25GBASE-LR and 25GBASE-ER Interoperation

Chief Editor, P802.3cc

Outline

25GBASE-LR and 25GBASE-ER Interconnected With 4dB (min) Attenuator – OMA

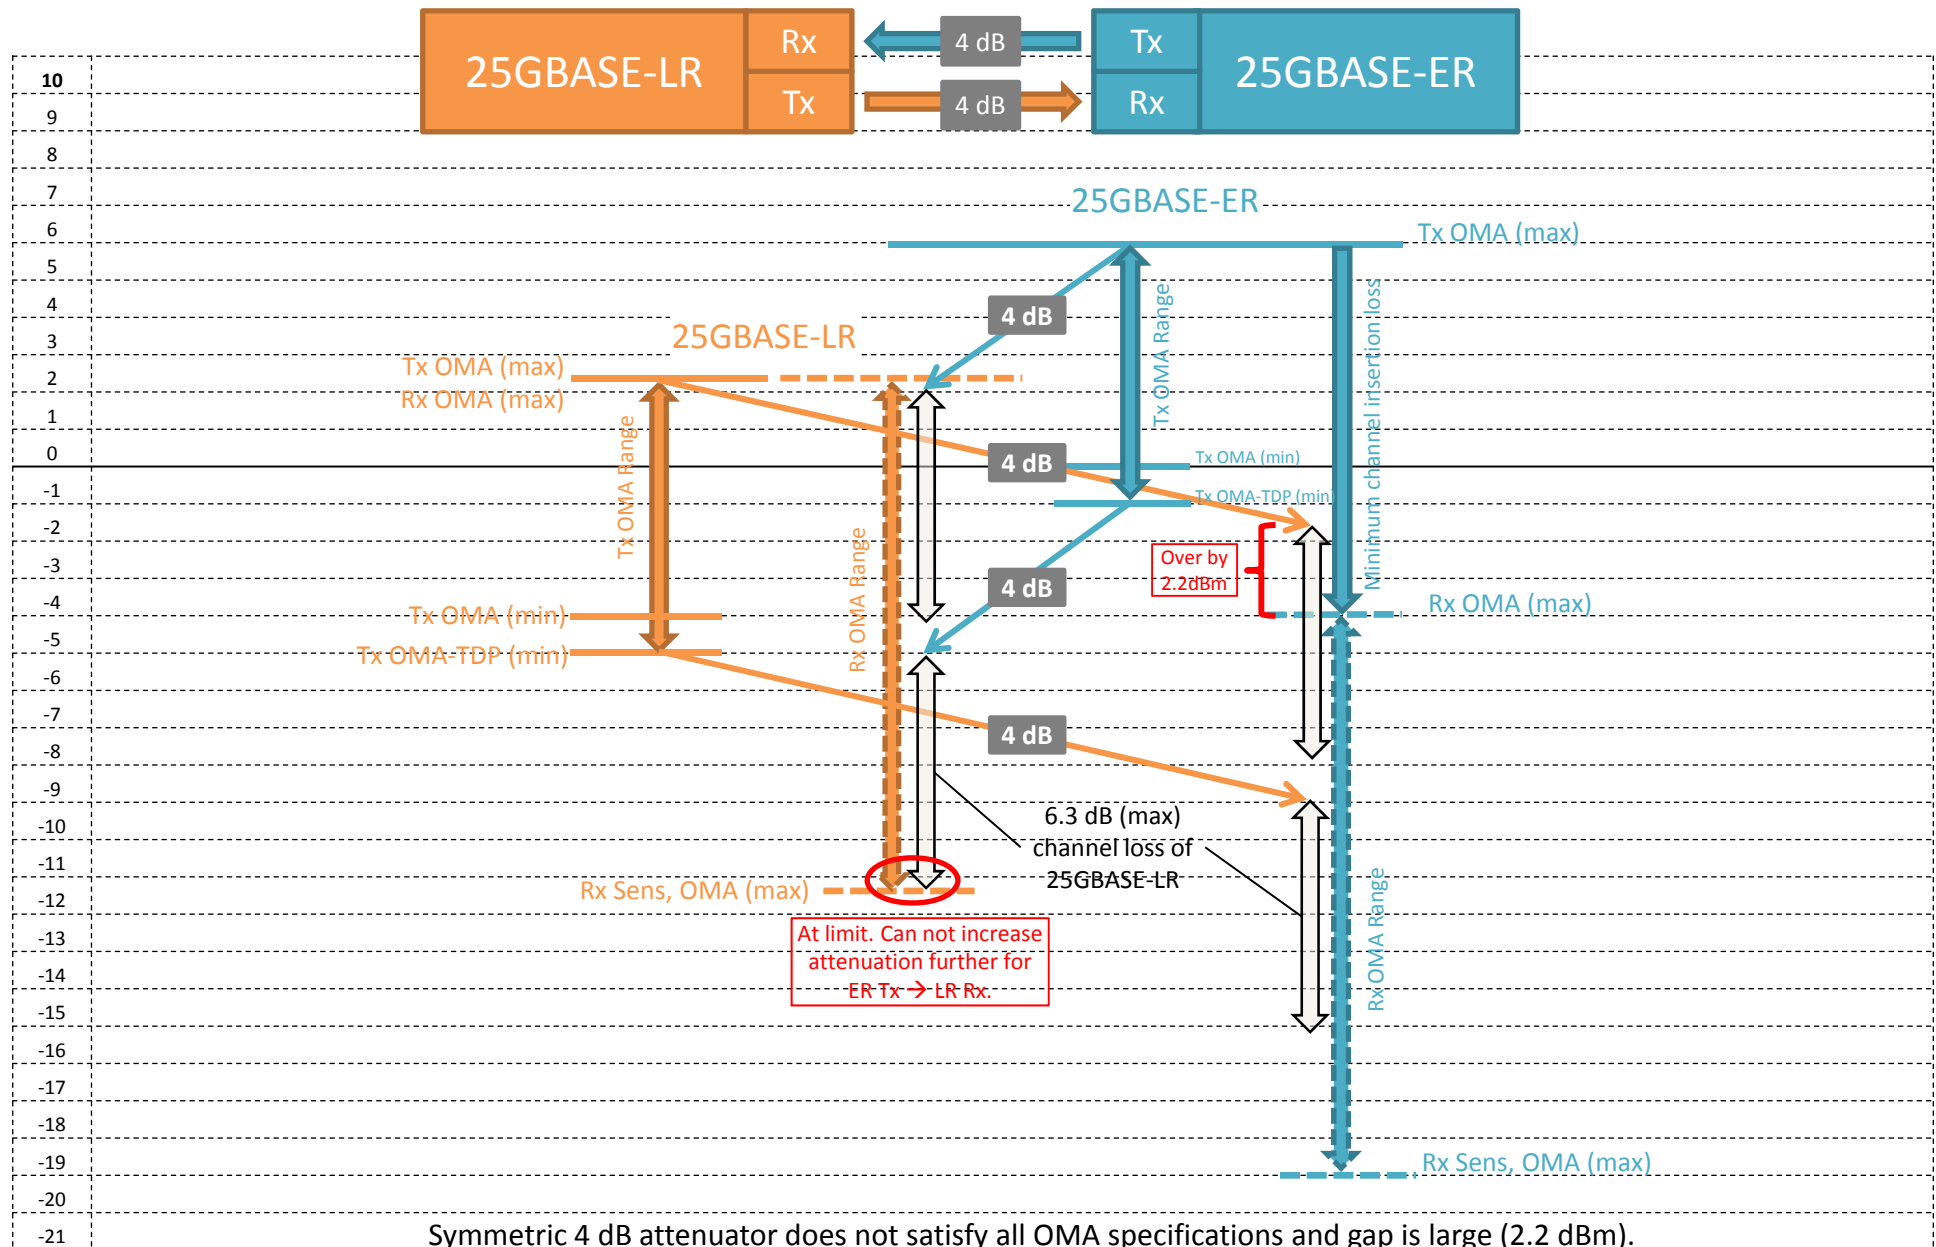
1. Several comments indicated that the conditions for interoperability of 25GBASE-LR and 25GBASE-ER needed clarification to ensure that the min/max specifications for OMA and average power (P_{avg}) are satisfied.
2. One possible solution is to make the following 3 additions / changes to the specification:
 1. For channel loss of 0 – 4 dB:
 1. Require 5 ± 1 dB attenuator when connecting 25GBASE-ER transmitter (Tx) to 25GBASE-LR receiver (Rx).
 2. Require 8 ± 1 dB attenuator when connecting 25GBASE-LR Tx to 25GBASE-ER Rx.
 2. For channel loss of 4 – 6.3 dB:
 1. Require 2 ± 1 dB attenuator when connecting 25GBASE-ER Tx to 25GBASE-LR Rx.
 2. Require 5 ± 1 dB attenuator when connecting 25GBASE-LR Tx to 25GBASE-ER Rx.

25GBASE-LR and 25GBASE-ER Interconnection Attenuator Tolerance Considerations – OMA

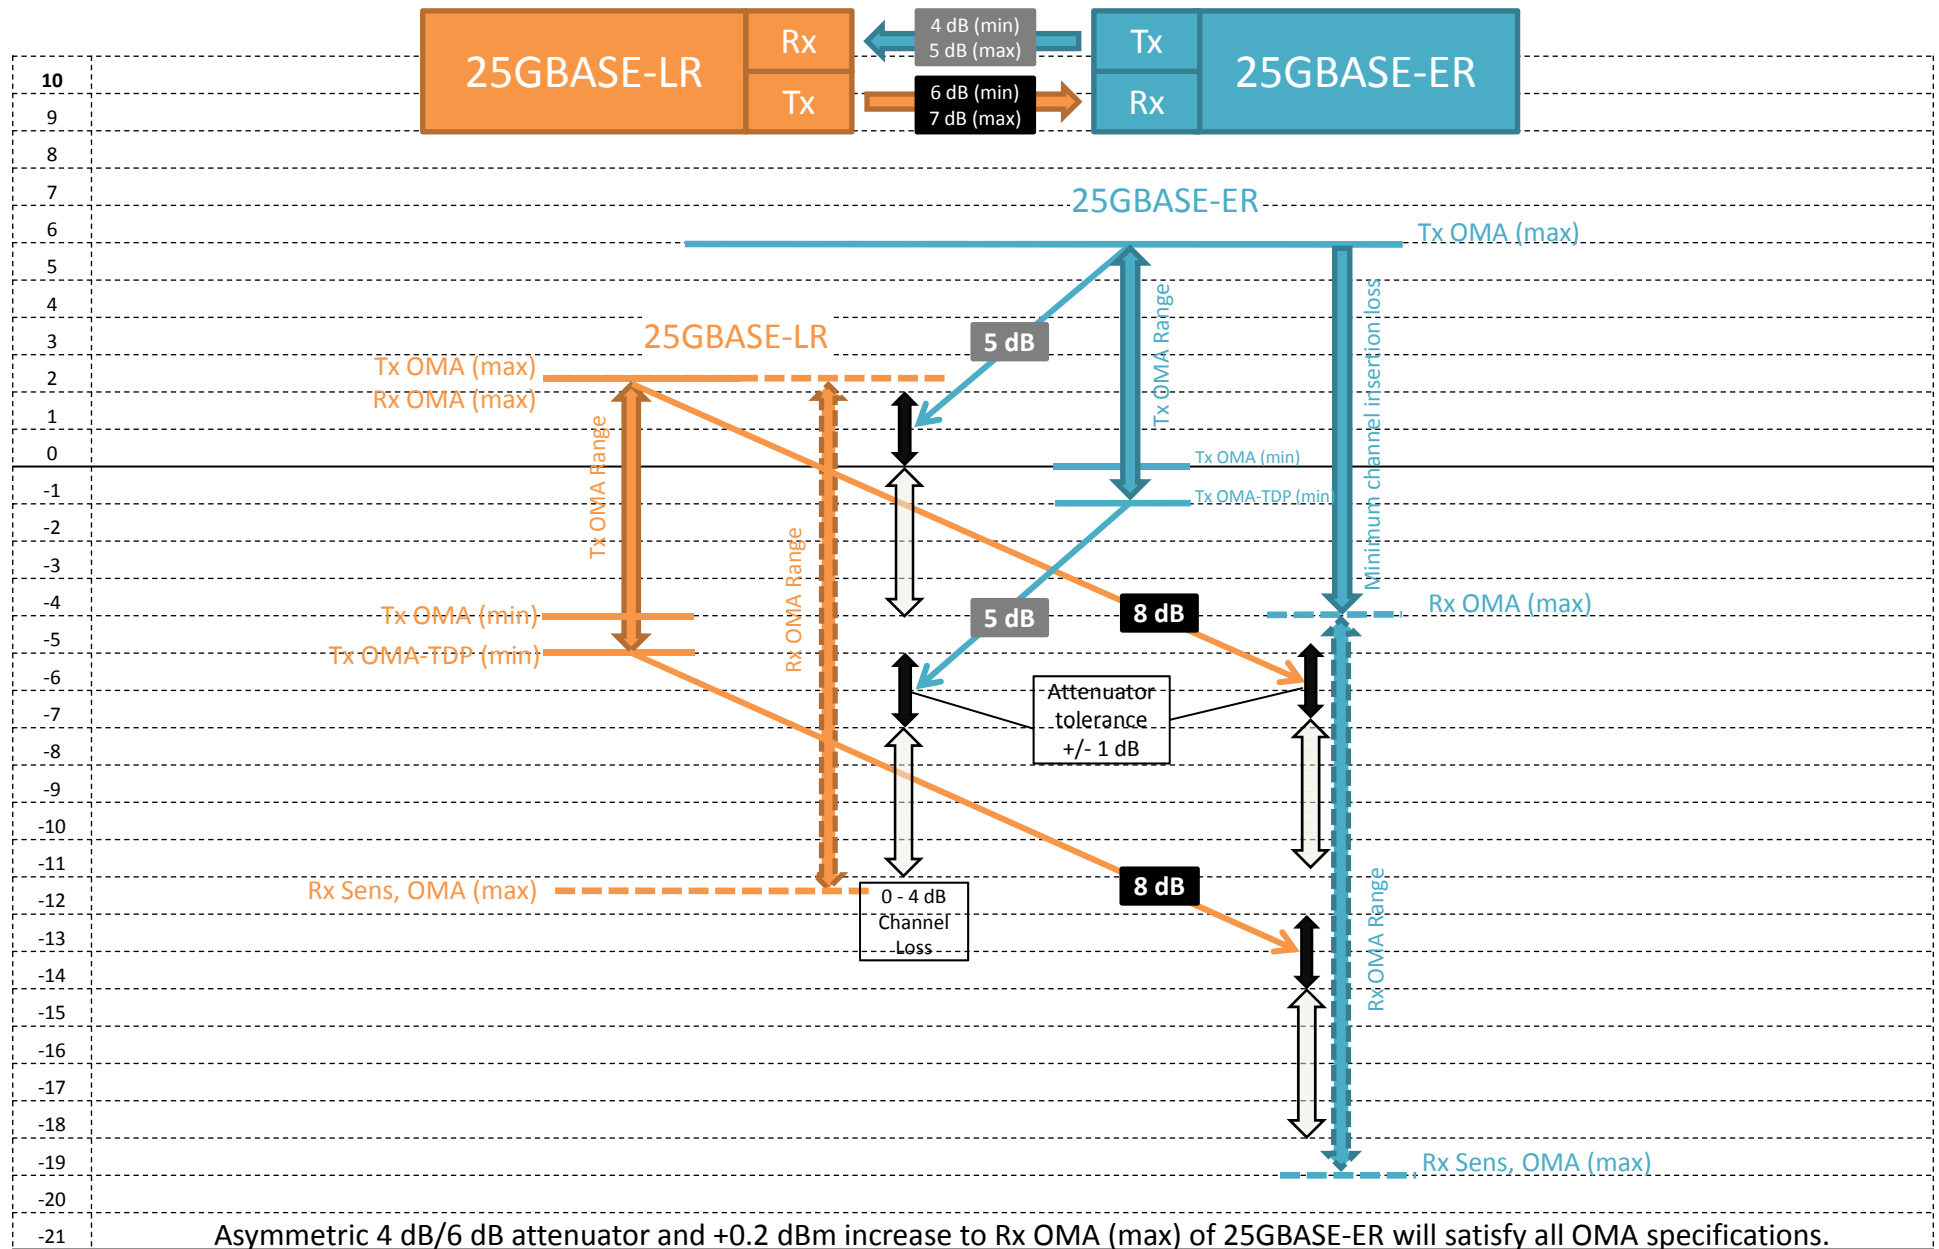
1. Interoperation between 25GBASE-LR and 25GBASE-ER can be achieved adding two requirements to the channel loss and making one minor change to the 25GBASE-ER specification:
 1. For channel loss of 0 – 4 dB:
 1. Require 5 ± 1 dB attenuator when connecting 25GBASE-ER transmitter (Tx) to 25GBASE-LR receiver (Rx).
 2. Require 8 ± 1 dB attenuator when connecting 25GBASE-LR Tx to 25GBASE-ER Rx.
 2. For channel loss of 4 – 6.3 dB:
 1. Require 2 ± 1 dB attenuator when connecting 25GBASE-ER Tx to 25GBASE-LR Rx.
 2. Require 5 ± 1 dB attenuator when connecting 25GBASE-LR Tx to 25GBASE-ER Rx.
2. This proposal assumes the current specifications for 25GBASE-ER (i.e. per D2.0 which assumes APD receiver). If the link budget for 25GBASE-ER is shifted to allow for PIN receivers, as has been proposed elsewhere, then further considerations will be needed.
